GOVERNMENT OF THE DISTRICT OF COLUMBIA
DEPARTMENT OF TRANSPORTATION

MEMORANDUM

SUBJECT: Zoning Commission Case No. 14-01A – Jemal’s Hecht’s – 1401-1535 New York Avenue,
NE PUD Modification and related Map Amendment

Figure 1 Site Access (Source: Applicant Submission)

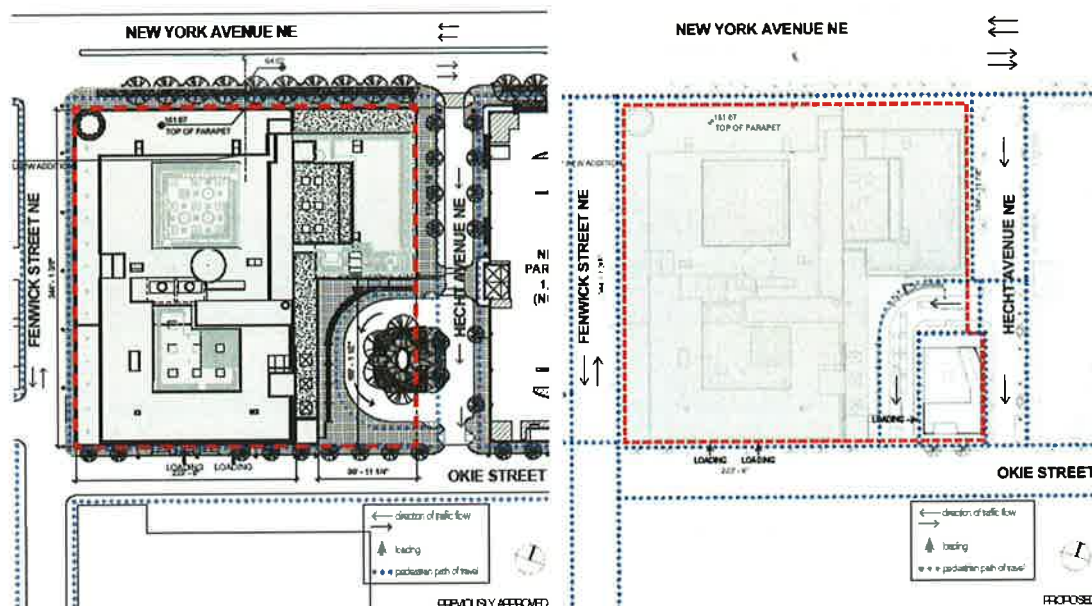
The Applicant has proposed to modify the private roadway access from two curb cuts off of the private Hecht Avenue to one curb cut on Hecht Avenue and a new curb cut on Okie Street. The proposed new curb cut meets DDOT standards and is acceptable. See figure 1 below.
